2-G-26-HZ
APPLICATION FOR CERTIFICATE OF APPROPRIATENESS

2008 Washington Ave. 37917
Edgewood-Park City H

Staff Report

File Number: 2-G-26-HZ

Site Plan

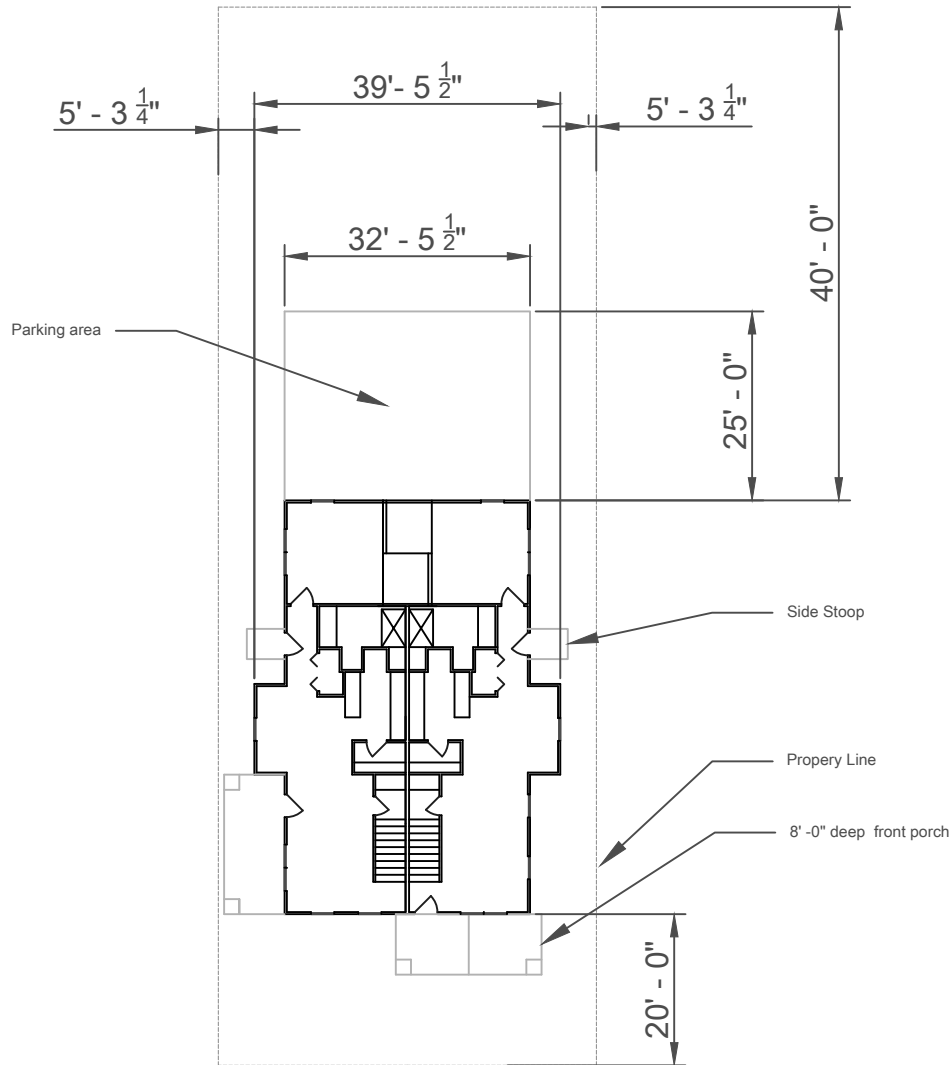
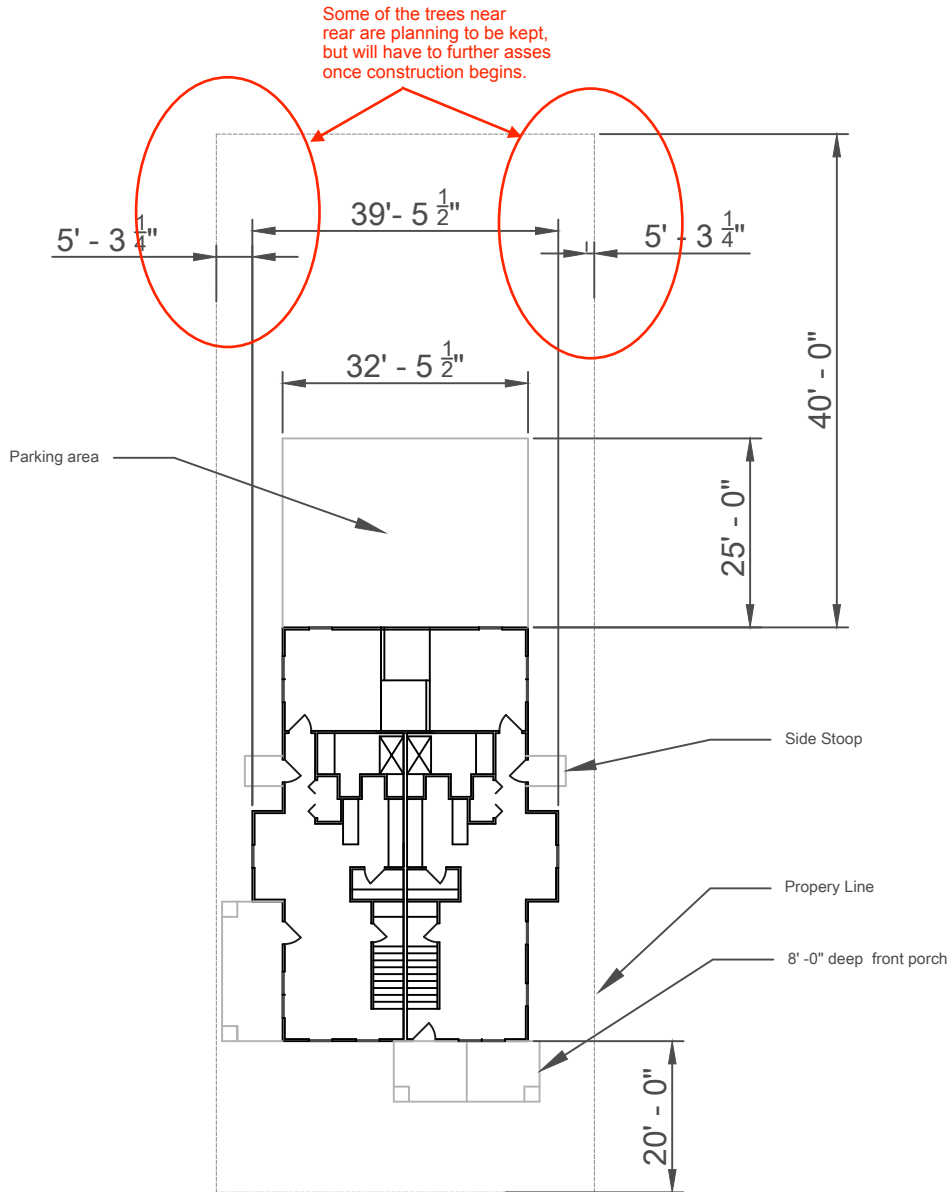
2. The duplex is proposed to be set 20' from the front property line, with the porch at 12' from the front property line. The average of the blockface is 28', with the adjacent properties set 23' and 30' from the front property line. Middle Housing standards require the new building to reflect the average, plus or minus five feet. The building should be recessed towards the rear property line (closer to the average of 28' or 30') to maintain the existing streetscape pattern and reflect the previous house's front setback. The interior side setbacks are compatible with the overall context.

3. The proposed parking is a concrete pad at the rear of the property, which is assumed to be accessed from the alley. Parking accessed from the alley preserves the existing streetscape by avoiding new curb cuts. The final site plan should meet City Engineering and Zoning standards, with minor revisions to be approved by staff.

12. Guidelines encourage the preservation of significant landscape features such as mature trees. The mature shade tree towards the northeast corner of the lot should be preserved if possible, which may be facilitated by moving the duplex towards the rear property line.

- 1) Setback to be revised to align with the blockface, with final site plan submitted to staff for approval;
 - 2) Site plan, parking, and elevation drawings to meet all relevant City Engineering standards and aspects of the City zoning code;
 - 3) Applicant to submit an accurate foundation profile on all elevations to staff for review, with major modifications to the foundation height to return to the Commission for review;
 - 4) Final drawings to include a section showing brick foundation and siding overlap, and a profile depicting window trim with projecting sills;
 - 5) Final siding specification to feature 4" reveal and a smooth finish and cornerboards, with specs submitted to staff for approval;
 - 6) Porch balusters to be set into the top and bottom rails;
 - 7) Applicant to submit final window specifications to staff for review.
-

Elevations

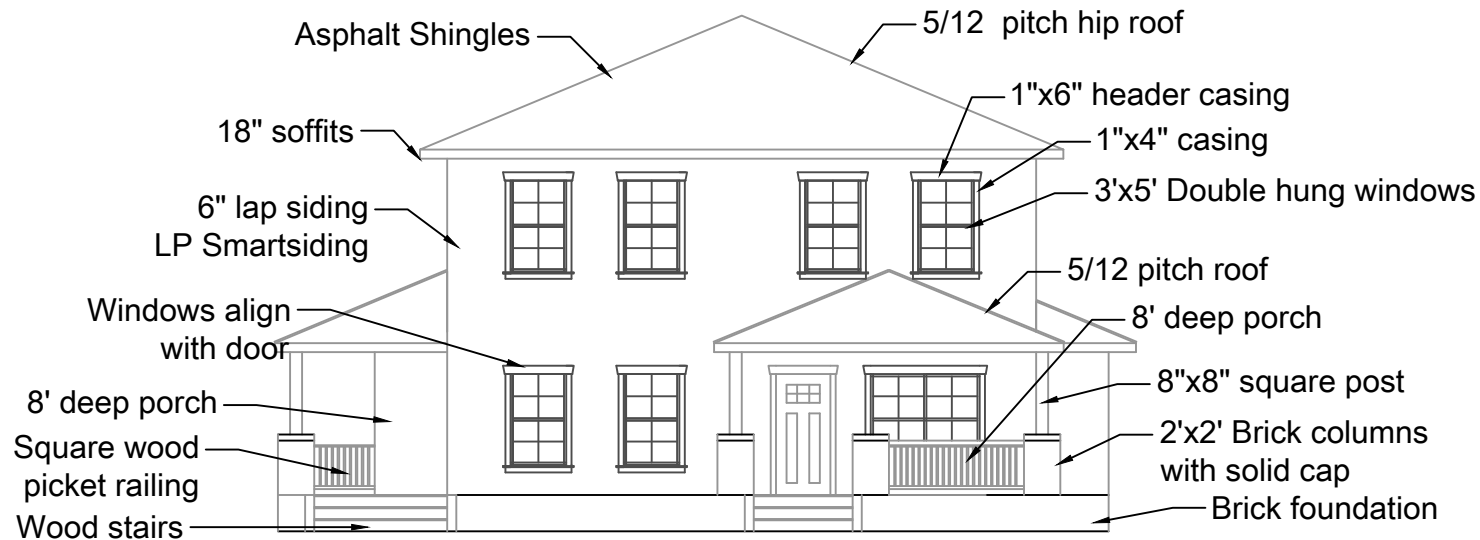
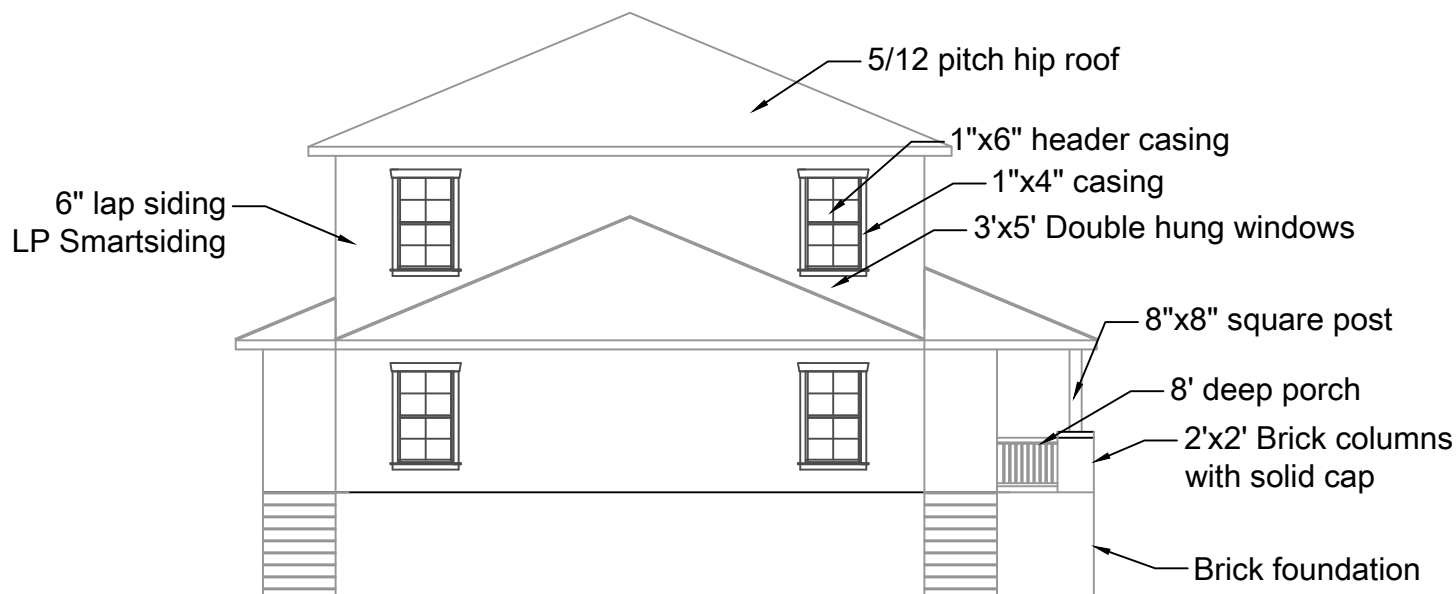
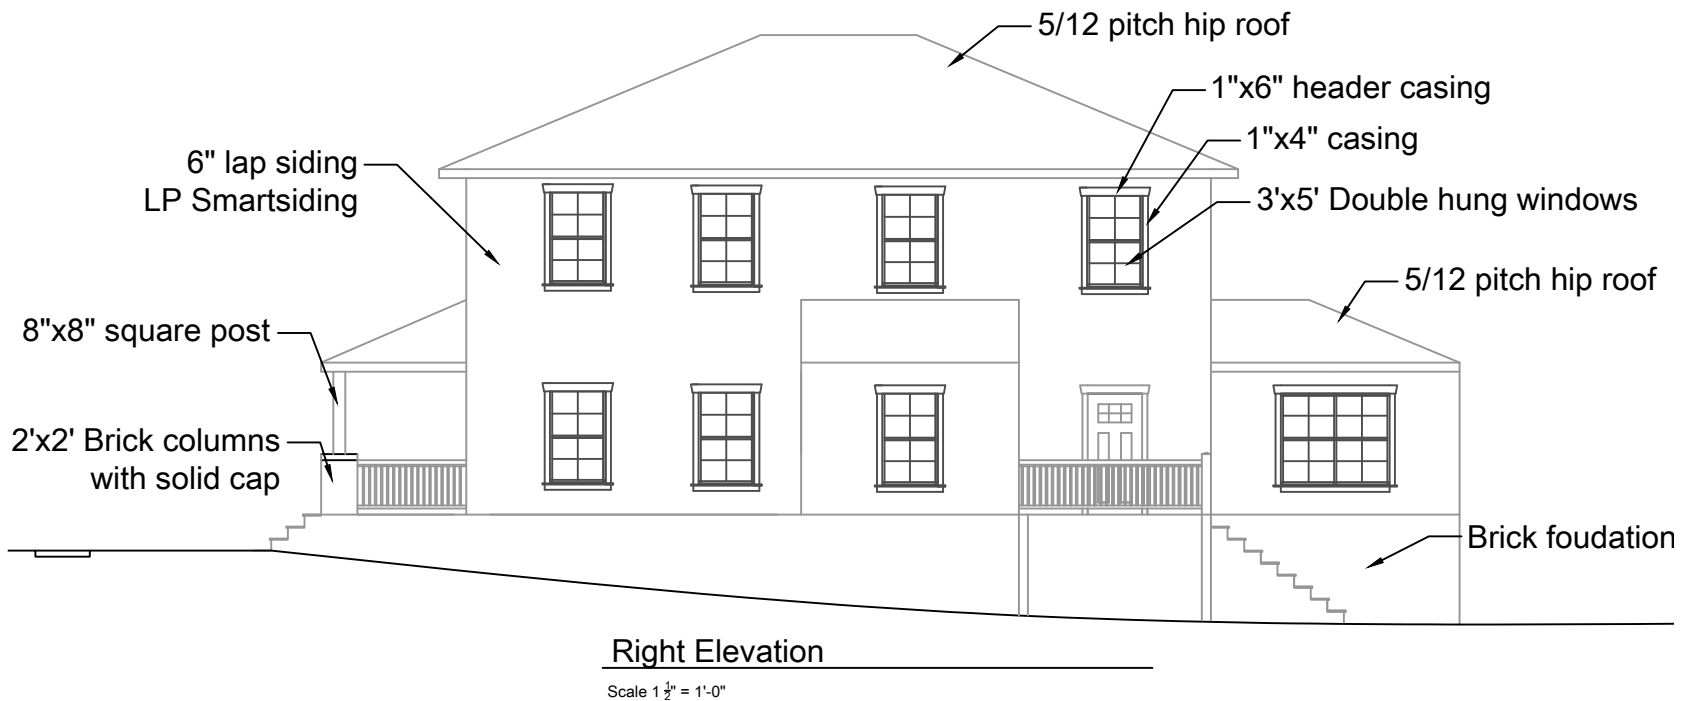
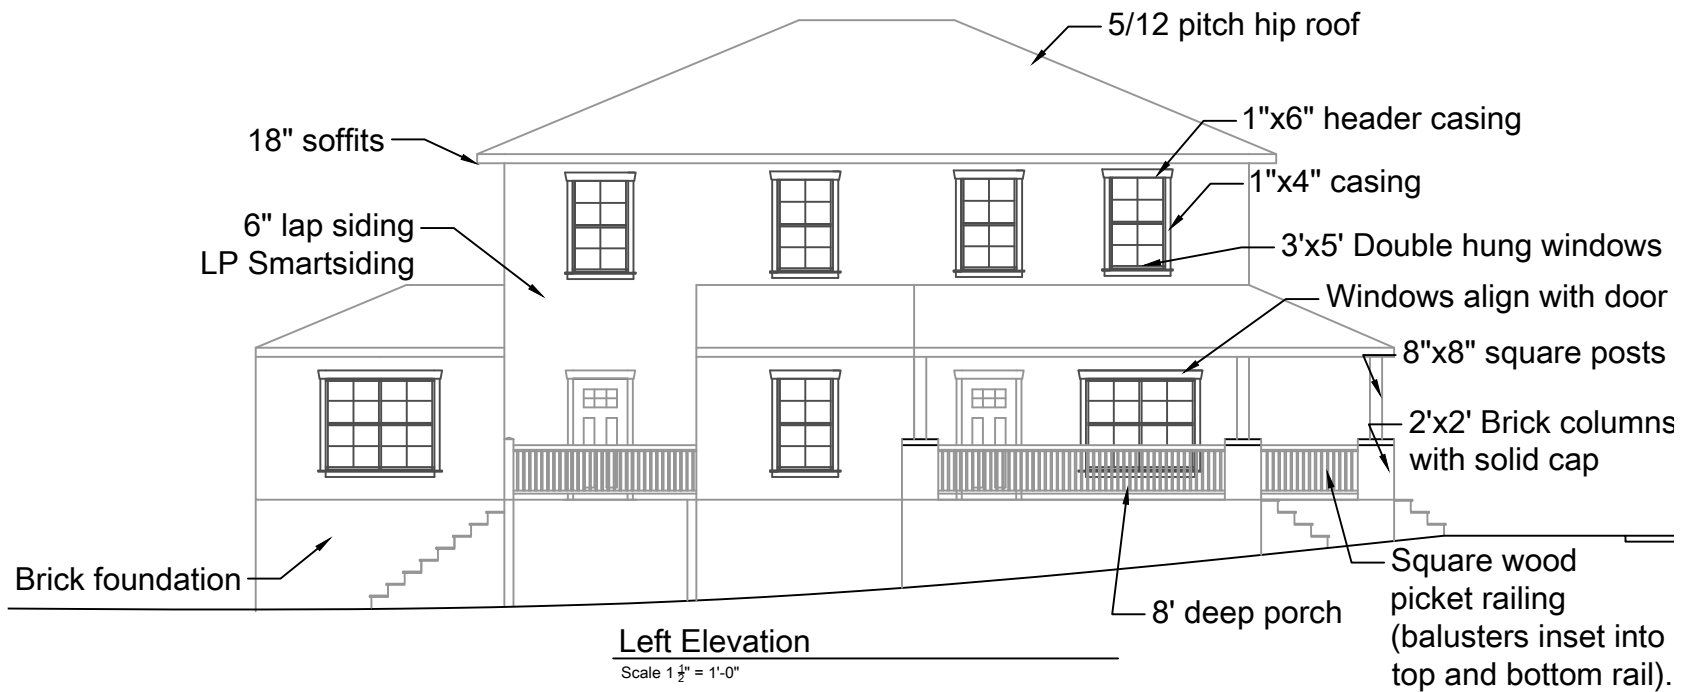
5. The hipped roof with 18" eave overhangs is appropriate for the Four Square-inspired design. Middle Housing standards require a 6/12 pitch, or a more complex, roof to meet Zoning standards.

6. The façade uses an 8' deep, partial-width front porch, with an additional porch on the left side elevation. The proposed 8" by 8" square posts on brick columns are appropriate for the selected style. On the guardrail, the balusters should be set into the top and bottom rails.

7. The foundation is described as measuring approximately 6'-8" tall at the rear elevation. The adjacent houses do feature significantly raised foundations, though 6'-8" may still be taller than the context. The foundation at the façade should reflect the existing houses along the blockface (approximately 1'-2' tall). The applicant should submit an accurate foundation profile based on the site's topography and the revised front setback to staff for review. Major revisions to foundation height would return to the Commission for review.

8. The proposed brick-clad foundation is appropriate. The applicant should submit a section indicating the brick foundation aligning with the face of the siding above (similar to historic brick foundations paired with lap siding), instead of projecting outwards from the siding.

9. Guidelines recommend that "where fiber cement board and other wood alternative materials are selected, use a smooth finish and maintain a 4-inch reveal compatible with historic details." The siding is currently proposed with a 6-inch reveal. The final siding specifications, whether LP Smartsiding or fiber cement, should be revised to a 4" reveal with a smooth finish, and submitted to staff for approval. The design should also feature 4" cornerboards.

11. The proposed window trim (6" headers with 4" trim) contributes to the design, but the window trim should include projecting sills in a design similar to historic window trim and sills. This will also fulfill a requirement of the Middle Housing standards. Sills are indicated on the elevation drawings but only described as 4" trim - final drawings should indicate the window trim via a profile drawing and be submitted with final elevations.
